Groundwater Transfer Review Summary Form

Transfer/PA # T- 13713

Application: T-13713

Applicant Name: Kittredge Properties LLC

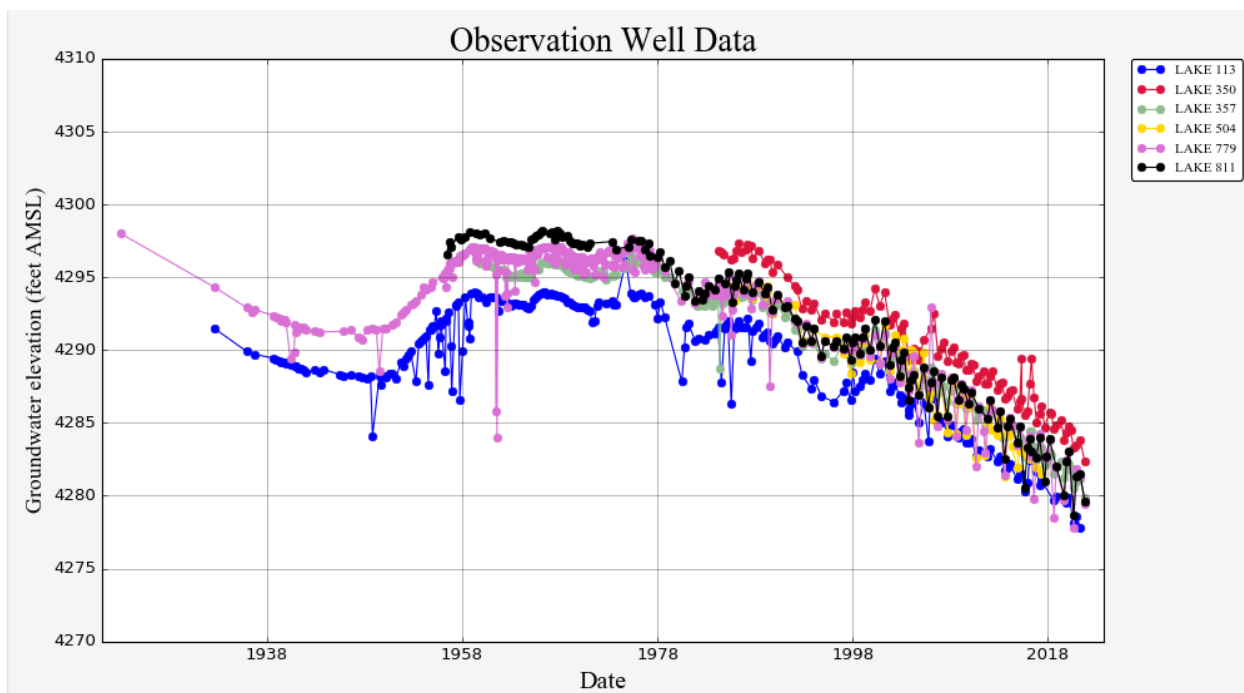
The nearest authorized well to the proposed APOA is POD 1 under certificate 53860 (LAKE 389) which is located ~6600 feet to the northeast. The potential increase in drawdown was calculated using the Theis equation (see attachments). The values used for the calculation are conservative and appropriate until better values become available. The calculation used an intermediate storage coefficient (0.001). The transmissivity used in the calculation (15,000 ft²/day) is from Morgan (1988) and McFarland and Ryals (1991). At the pro-rated pumping rate of the full duty over the full irrigation season (1.17 cfs), the results indicate a drawdown of <3 feet, which should be within the capacity of the nearby well.

The long term impact on the groundwater system should be the same. That impact is to continue contributing to the ongoing annual Fort Rock Classified area groundwater level decline. See attached hydrograph.
